SSD-5251: TfNSW response to Dubbo Project for Mod 1- Project layout and processing changes

TAB A Additional Information to address impacts along the Country Rail Network

Figure 1: Project Site and Rail Corridor

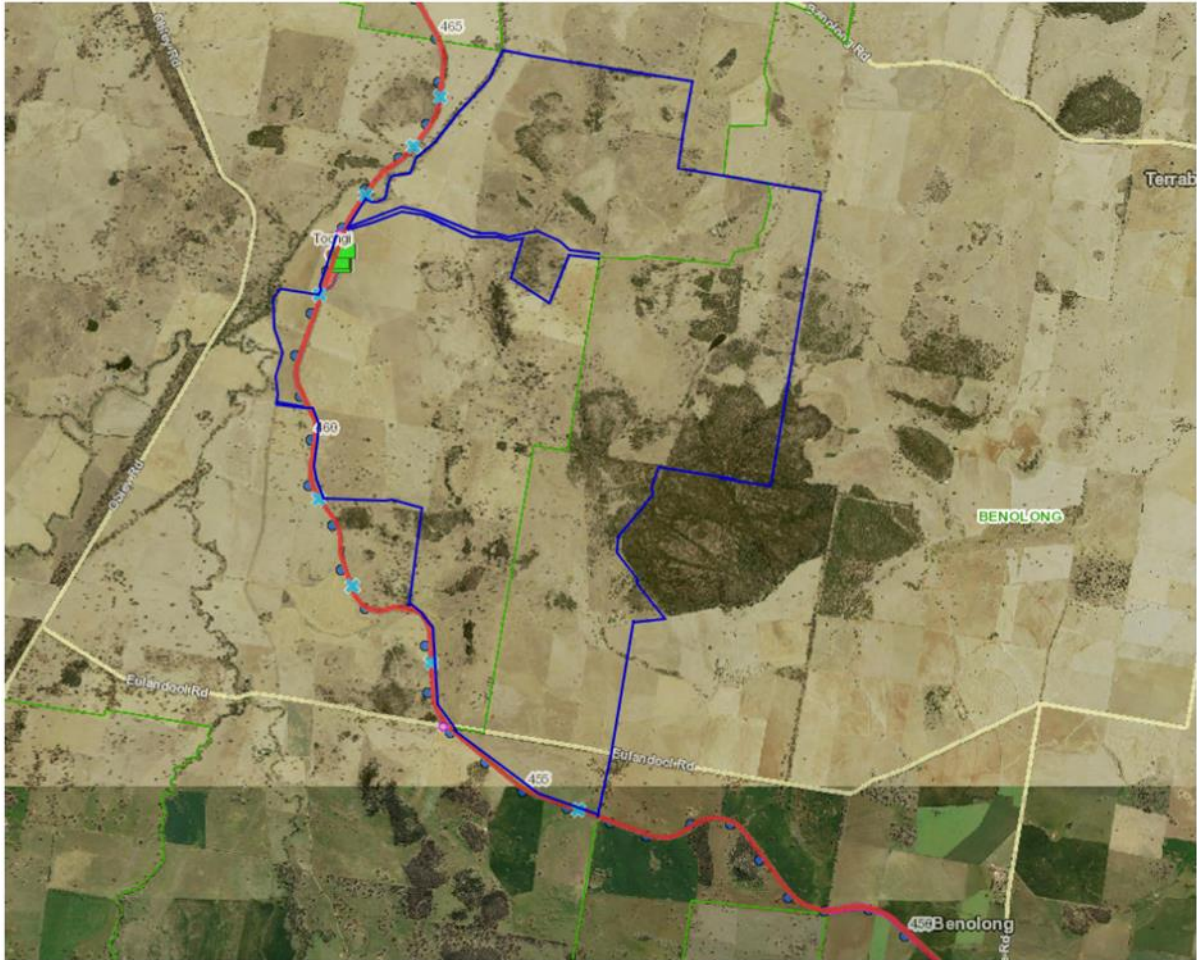
The modification application seeks approval for construction and operation of a range of additional plant, the relocation and realignment of a range of approved Project components, an increase on the approved reagent transportation rate and an extension of the life of the project on the Land (delineated in blue in Figure 1) which is within and immediately adjacent to the non-operational rail corridor from Dubbo to Molong.

The proposal seeks constructions works for a processing plant, administration area, construction of Chlor-alkali plant, the rail container Laydown and storage area, which appears to involve the penetration of ground. No further design details are provided to address Section 2.98 of the *State Environmental Planning Policy (SEPP) (Transport and Infrastructure) 2021* (previously Clause 86 of the ISEPP 2007) to confirm if there will be excavation greater than 2m in depth within 25m of the rail corridor.

Stormwater management and documentation has not been provided in this modification application to confirm if there will be any stormwater discharge into the rail corridor as a result of this modification application.

The Applicant is requested to address the matters outlined in Section 2.98 of the SEPP (Transport and Infrastructure) 2021 applies. If the matters are relevant, the Applicant will need to contact TfNSW to ascertain the documentation requirements that will need to be addressed as part of the response to submissions.

The Applicant is requested to confirm if there will be any stormwater discharge into the rail corridor during RtS stage and provide additional design documentation and calculations to confirm post development flows to not exceed pre-development flows (if required).
